# SUNSET VILLAGE FILING NO. 4

## CONSTRUCTION PLANS

**CONSTRUCTION DRAWINGS AMENDMENT, DATED APRIL 4, 2026 BY ENGINEERING LOCAL XPERTS, LLC.**

**SHEET TITLE:**  
FOREBAY DETAILS

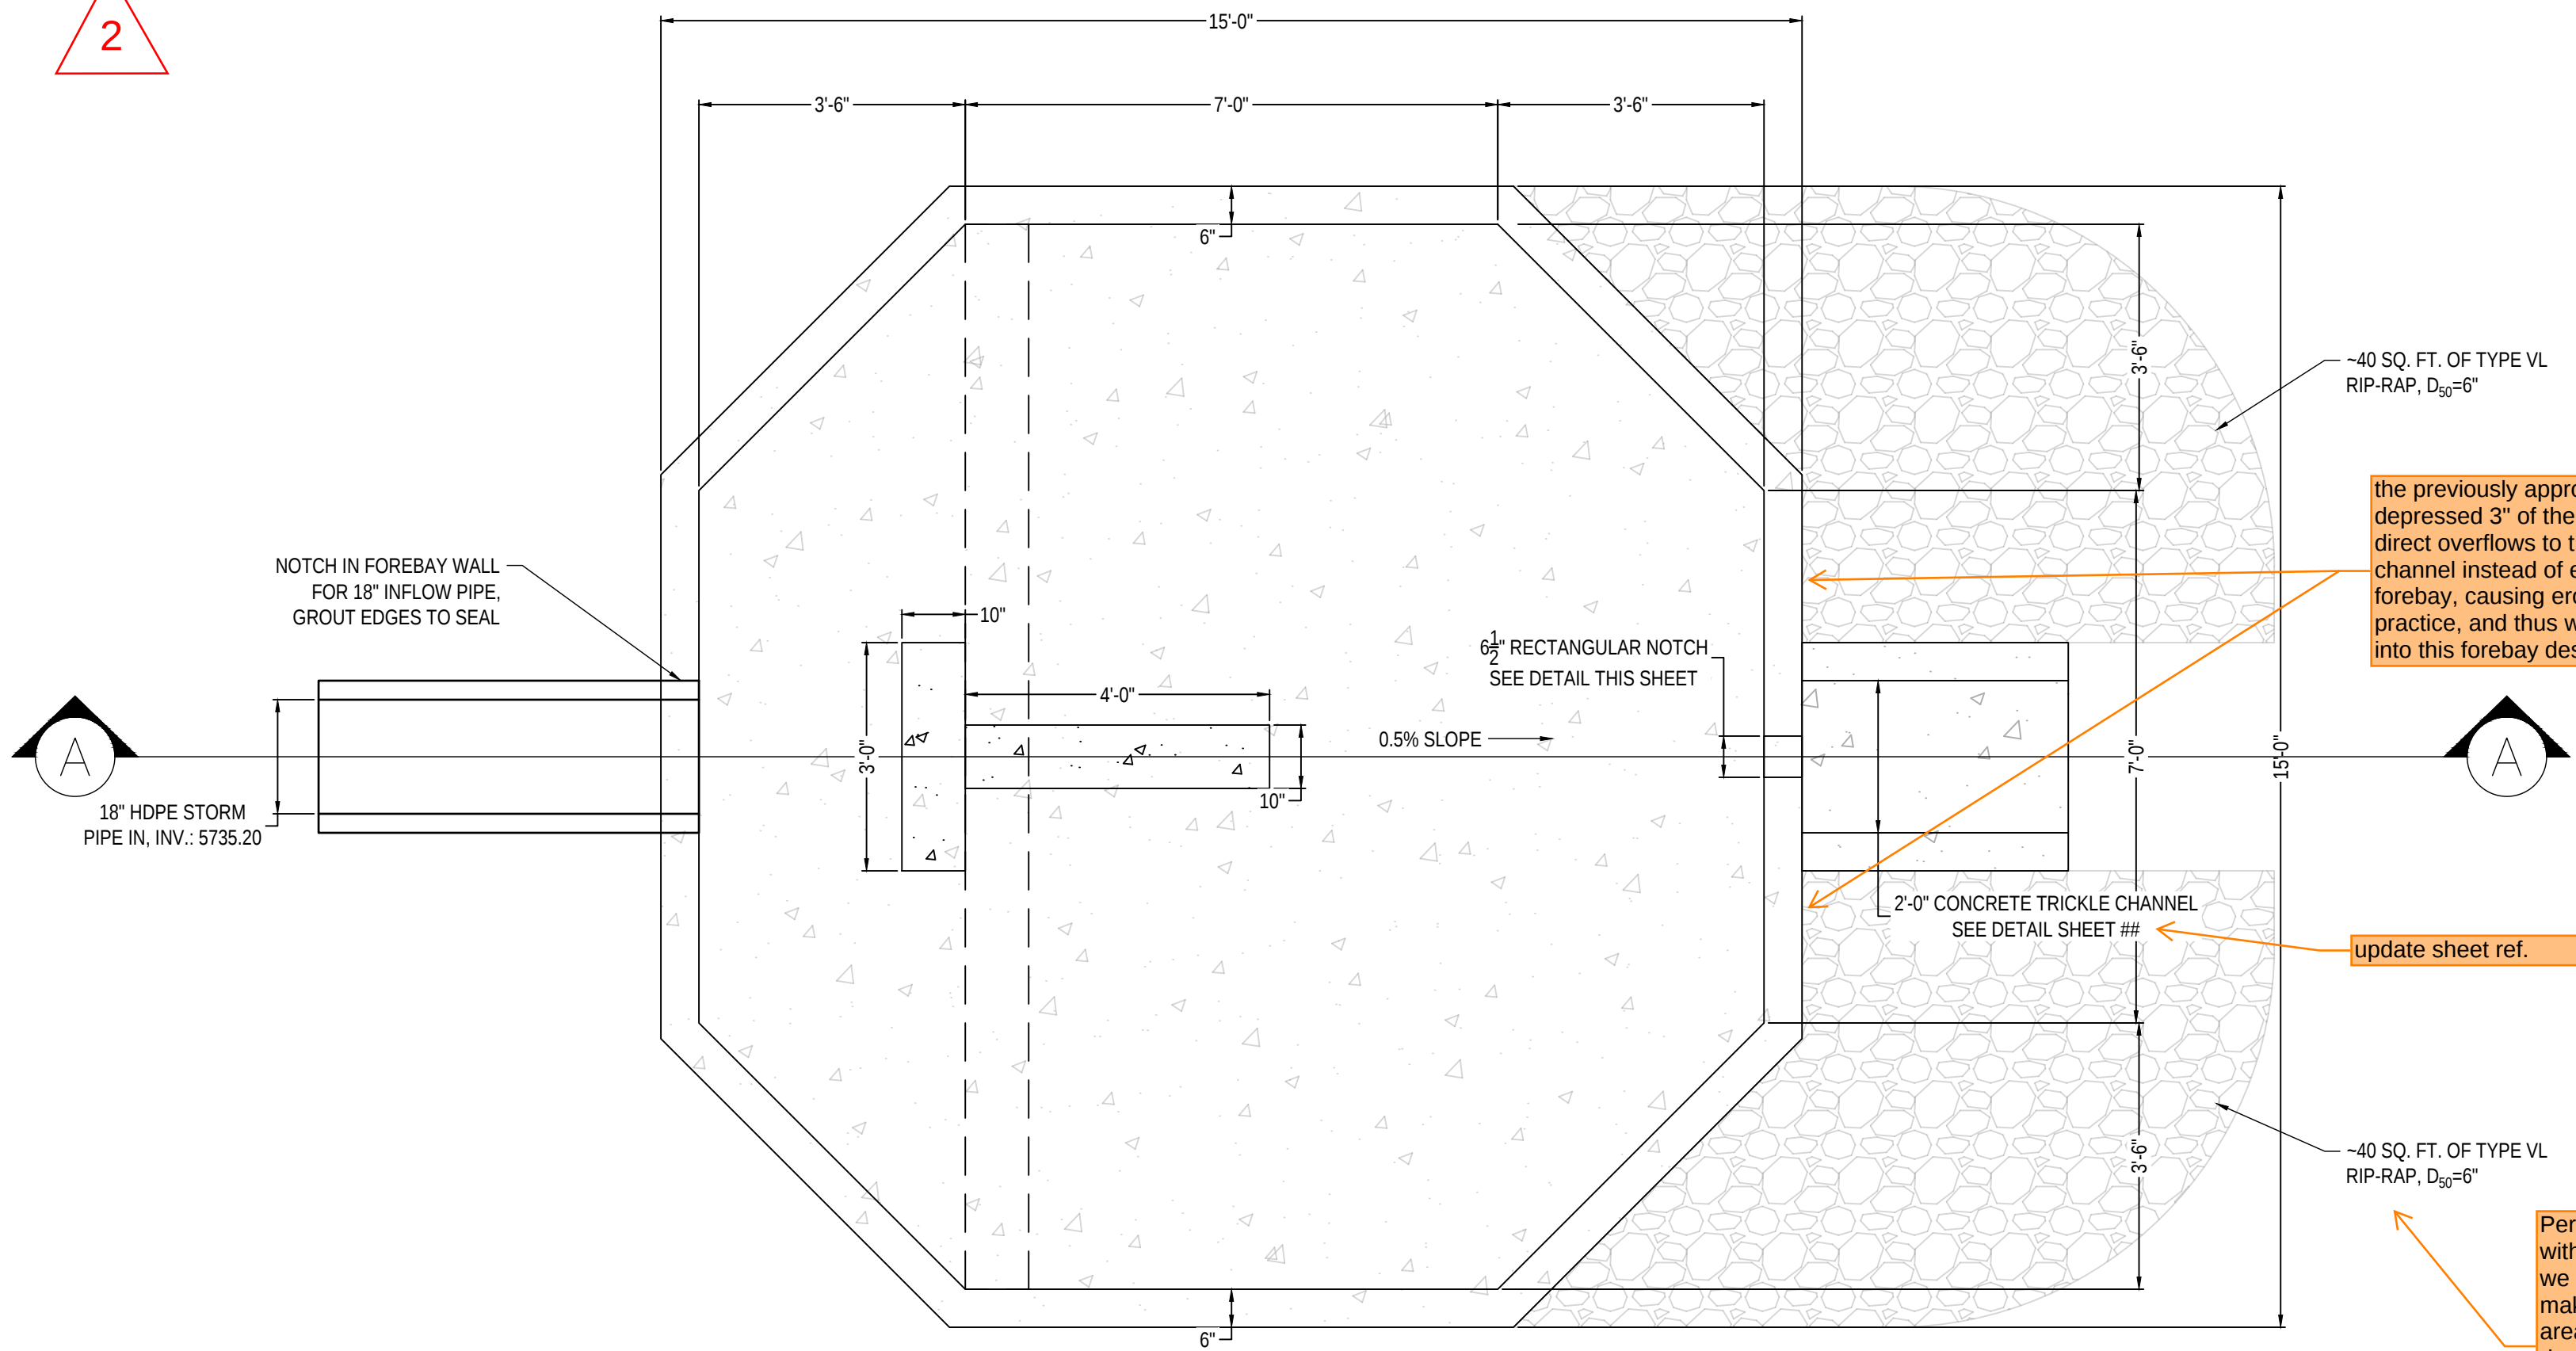
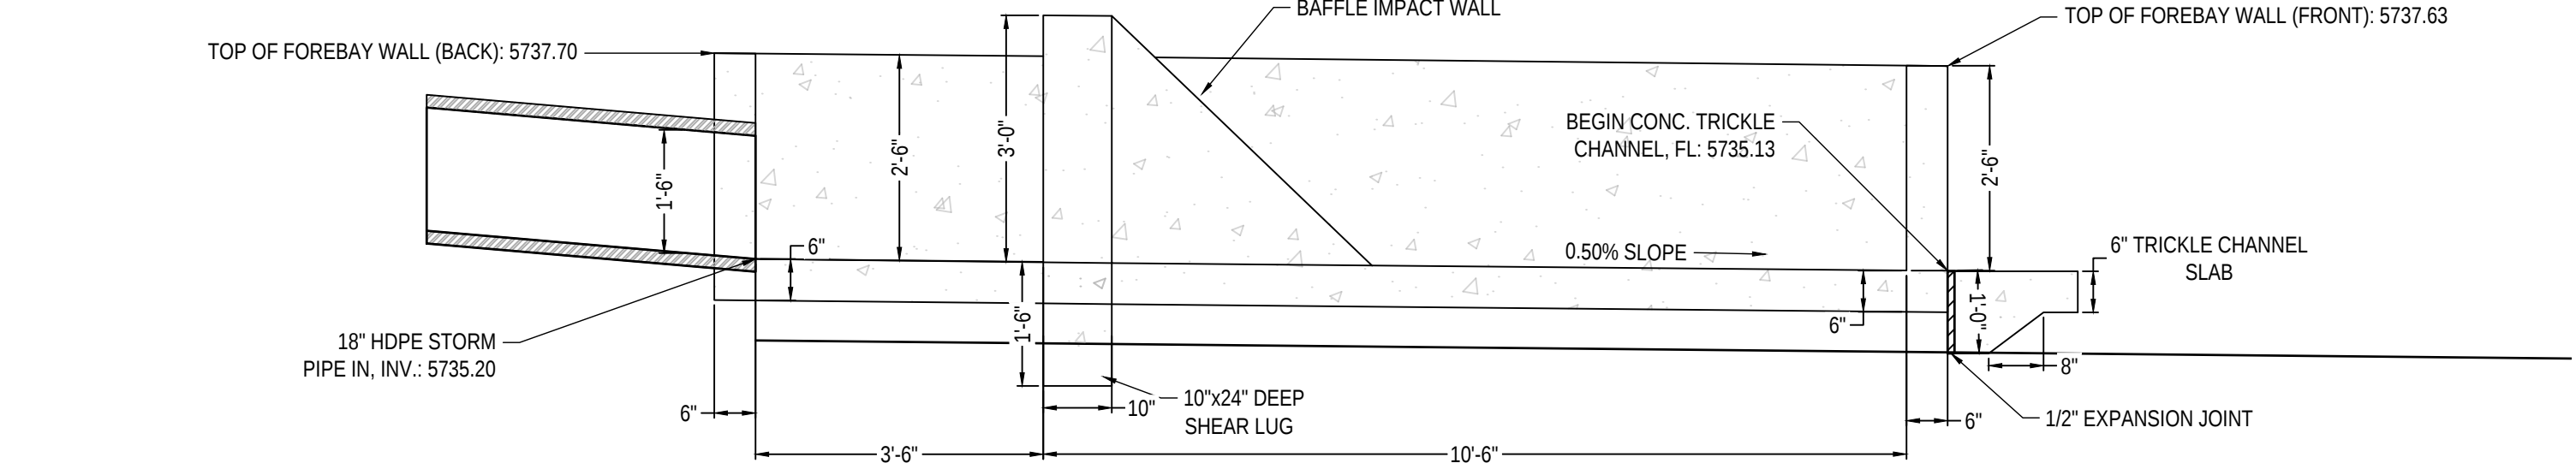
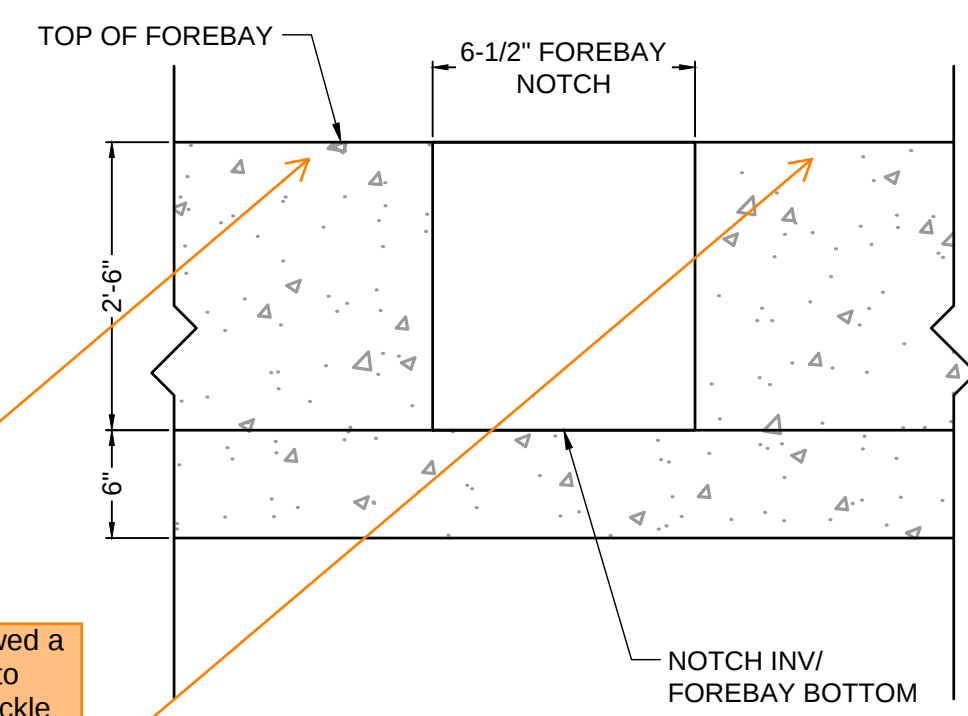
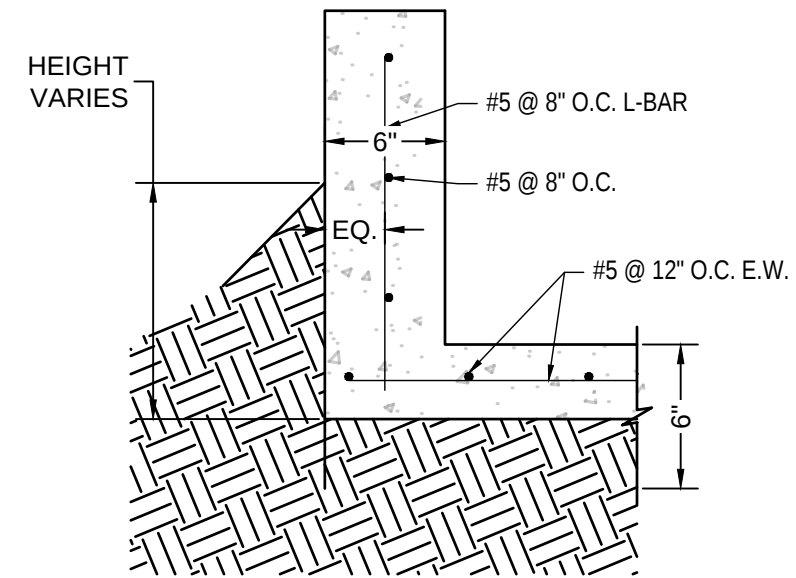
the previously approved plans showed a depressed 3" of the front wall here to direct overflows to the riprap and trickle channel instead of elsewhere around the forebay, causing erosion. This is good practice, and thus would be good to add into this forebay design.

update sheet ref.

Per recent in-person meeting with Richie about another site, we discussed the advantages of making most (if not all) riprap areas in and around ponds soil riprap instead of plain riprap. So please discuss with Richie if you have any questions and consider revising this to soil riprap.
